Staff Report to the Planning Commission

Application Number: **07-0228**

Project Description: Proposal to construct a 2 story commercial building with 2 commercial condos on the first story and 2 residential condos on the second story. The project requires a Minor Land Division, a Commercial Development Permit, and a Master Occupancy Permit.

PROJECT NUMBER
C2 of 5

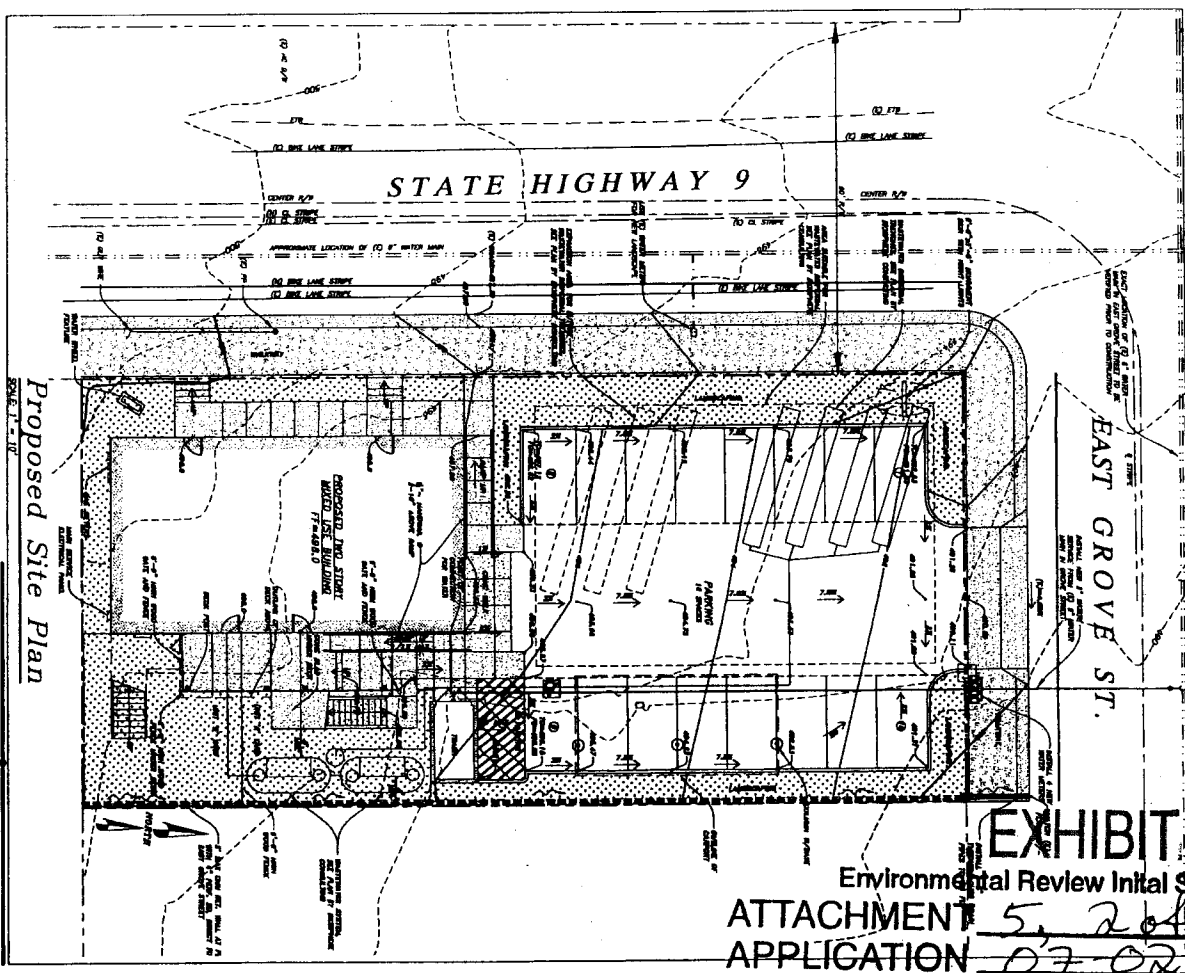
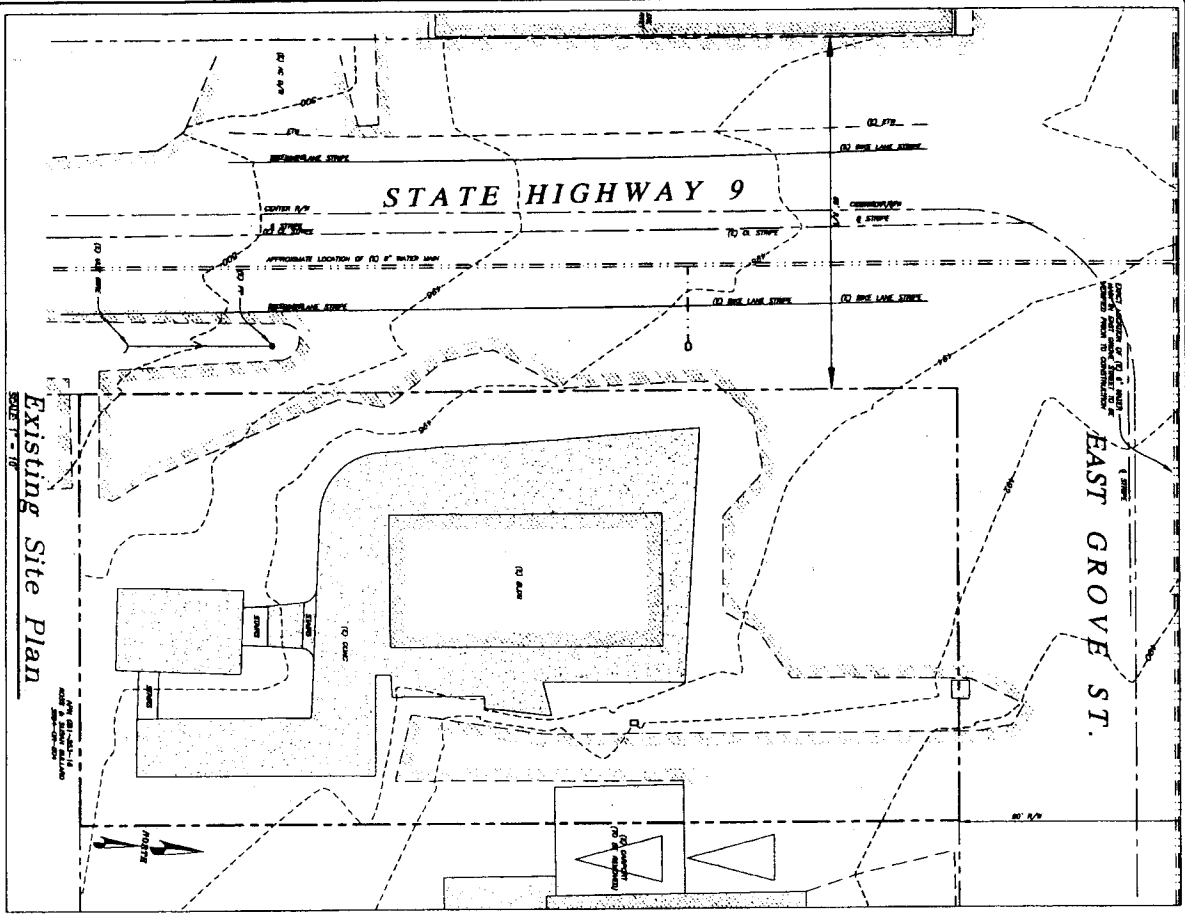
Comment 3# - Drainage Plan - Sheet C-2 of 5, does not show how roof runoff will be

handled. Moreover, for the most part, where slopes are indicated, the drainage from the concrete appears to be directed towards the parking lot. Please clarify and note all concrete slopes on the plan. As an aside it would be helpful if the sheet included a legend, at least for the existing site plan delineated on sheet C-2.

#3. The Drainage Plan, Sheet C2, has been updated with some flow arrows to indicate the above runoff patterns and a note is added for the mixed use building to indicate direction of runoff to the landscape areas.
